Product Upgrade

Upgrade Effective:
April 2016

Rexnord 1500 Series MatTop Molded Dynamic Nose-over Bar Upgrade

Specification drawing for the 170-millimeter width size (part number 10478853) of the 1500 Series MatTop Molded Dynamic Nose-over Bar.

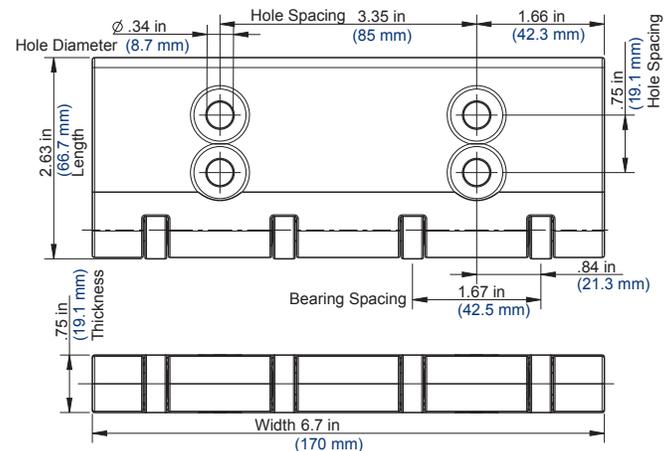
Rexnord now offers a molded dynamic nose-over bar for our 1500 Series MatTop® Chain. The modular design is offered in 3- and 6-inch widths, and 85- and 170-millimeter widths. It is available to order and ship as of April 2016.

To provide customers with a new design that features improved chain interaction with two bearings per 3 inches (76.20 millimeters) in width and raised bearings to help reduce friction. The molded design allows for easy assembly.

Is the new nose-over bar interchangeable with the machined Rexnord 1500 Series Nose-over bar?

Yes.
